TECHNICAL NOTE

LAND AT BURDELL ROAD, YAPTON, WEST SUSSEX RESIDENTIAL DEVELOPMENT

Client: Driftstone Homes Ltd
Reference: 6145

Date: July 2021

Figure 2.1: Summary Speed Survey Data

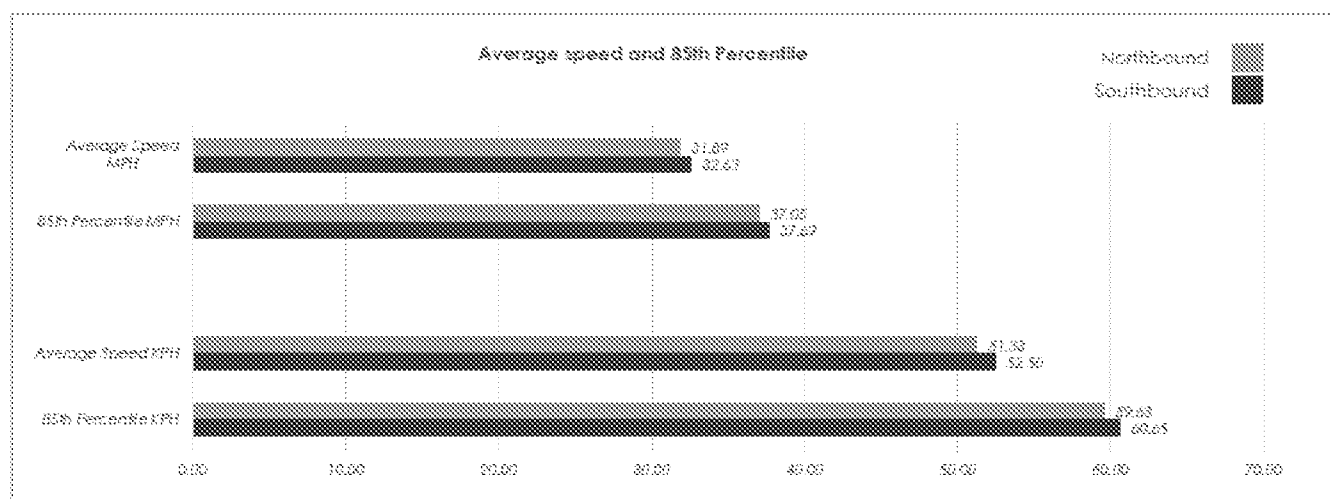
"ATC surveys taken during lockdown periods are acceptable for use in calculating 85th percentile speeds and concurrent visibility splay requirements but should not be used for traffic volume counts. The TS has taken a different approach where splays concurrent to the speed limit of 30mph and to a maximum design speed of 60kph (37.3mph) have been demonstrated. As speeds could be varying and above 37.3mph a 7-day speed survey is required to ascertain the up to date 85th percentile speeds in either direction, in vicinity of the access, along with amended vehicle visibility and pedestrian forward visibility splays in accordance with these recorded speeds."

- 2.2.1 An ATC speed Survey was undertaken between the 11th and 17th of July 2021 to establish design speeds on Burndell Road. The ATC data has been filtered in accordance DMRB CA 185 requirements. A summary of the speed data is provided in **Figure 2.1**.

- 2.2.2 The southbound design speed narrowly exceeds 60kph, a threshold at which DMRB CD 109 visibility requirements need to be considered. DMRB CD 109 identifies relaxations to the 'desirable minimum' stopping sight distance are permitted on Band B 60kph urban trunk roads. The low proportion of HGV's (<1%) on Burndell Road further supports relaxation from the desirable minimum as detailed in MfS 2 Section 10.1.

Drawing Status	FINAL		
Client	Driftstone Homes		
Project	Burdell Road, Yapton		
Drawing Title	Access Overview and Visibility Splays		
Scale	1:250	Date	July 21
Drawn By	SMO	Checked By	ALB
Drawing No.	2020-6145-001		Rev.
		I

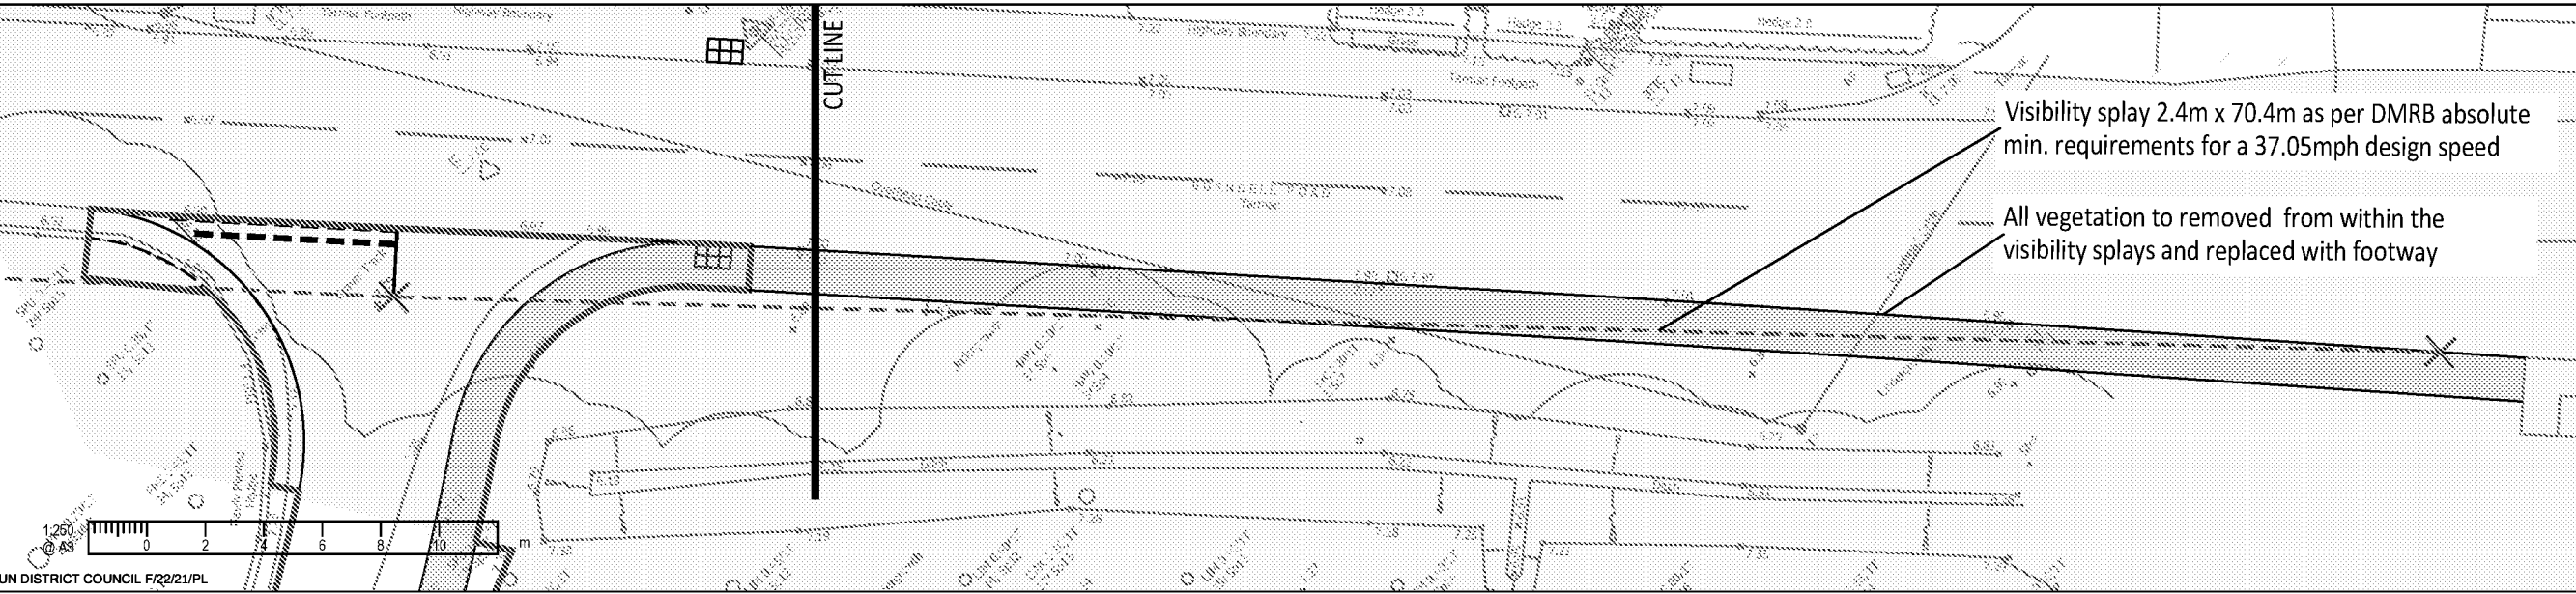
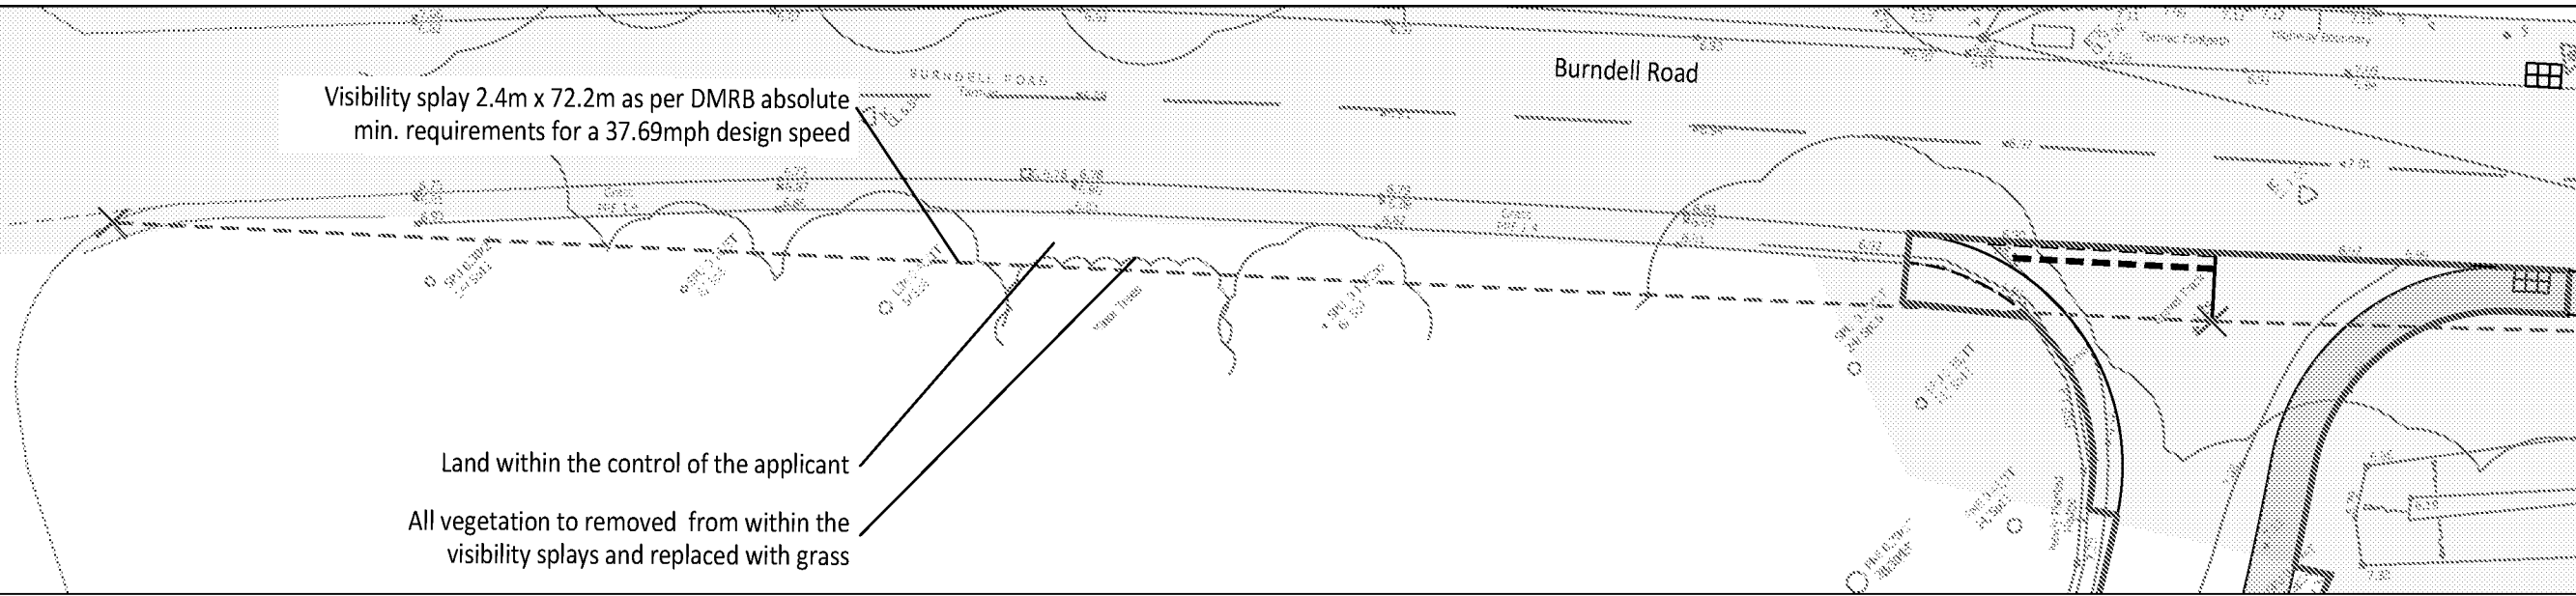
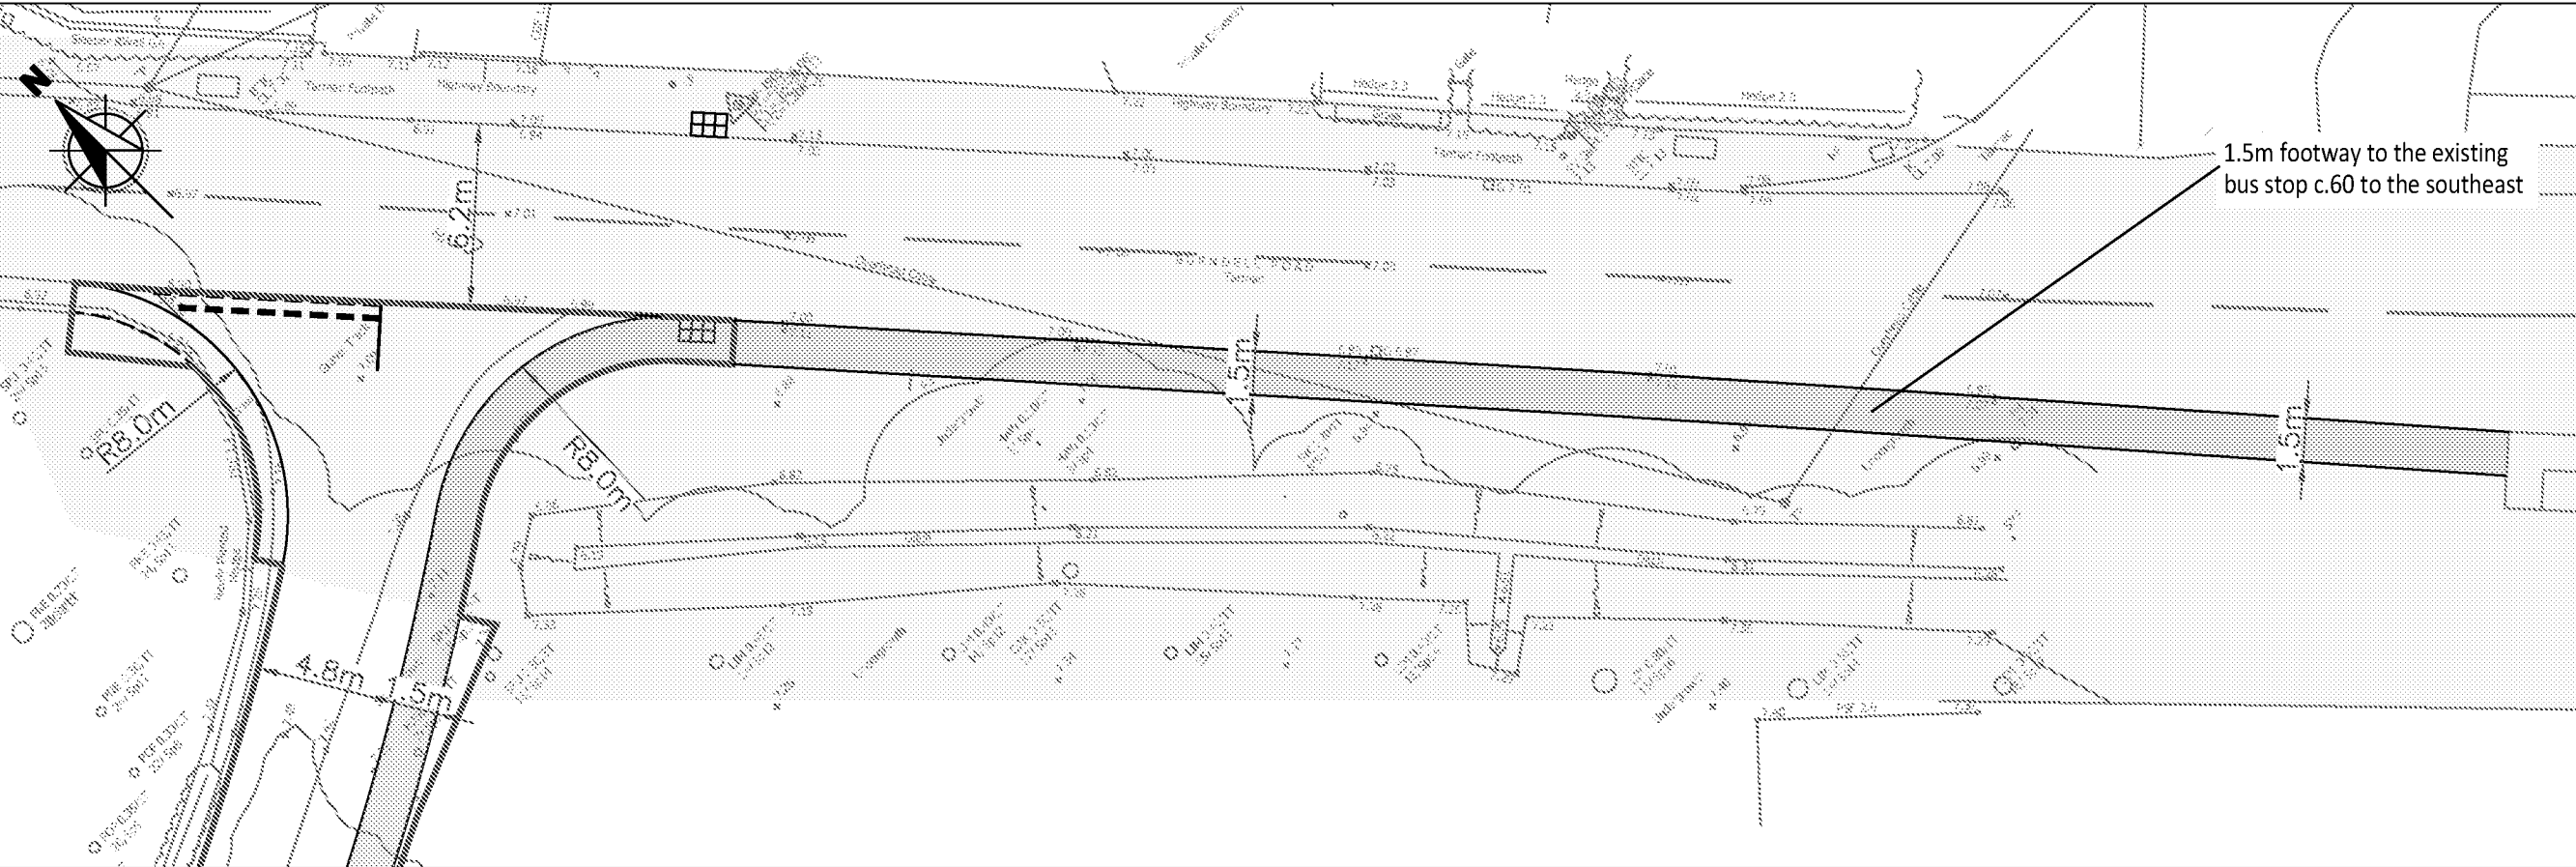
Locations: A – The access junction onto Burndell Road (Dwg. 2020-6145-001 Rev. H)

Summary: Risk of side impact collisions due to the visibility from the access road being obstructed by vegetation.

Although the post and rail fence will require removal, and the existing vegetation will be cut back, to obtain the visibility splay in both directions from the access road, the amount of overgrown vegetation present (brambles, nettles, low tree branches etc – see photos 1 and 2) will need constant maintenance to ensure that the visibility splays are not obstructed, especially to the south-eastern side of the access junction where approaching traffic will be closest to the give way lines as vehicles exit the development. Any obstruction to visibility is likely to increase the risk of side impact collisions at the access junction.

All vegetation, including low branches from adjacent trees, should be removed completely from within the proposed visibility splays, and replaced with either grass or a footway (to the south-east – see recommendation to problem 2.2).

- 2.2.3 The secondary direction visibility splay has therefore been shown in accordance with DMRB 'absolute minimum' requirements equating to a stopping sight distance of 72.0m. The primary direction visibility splay has also been provided in accordance with DMRB absolute minimum requirements for consistency (although speeds on this approach direction fall below the DMRB 60kph threshold) equating to a stopping sight distance of 70.0m. The revised primary and secondary visibility splays are demonstrated in **Drawing 2020-6145-001**.

Problem no.	Problem Accepted (yes/no)	Recommended Measure Accepted (yes/no)	Design Organisation Response	Over Seeing Organisation Response	Agreed RSA Action
2.1	Yes	Yes	All vegetation will be removed from within the visibility envelope. Vegetation to be replaced with grass to the north west and a 1.5m wide footway to the south east.	agreed	
2.2	Yes	Yes	The footway has been extended c.60m to the southeast to provide access to the existing bus stop.	agreed - noted improvement
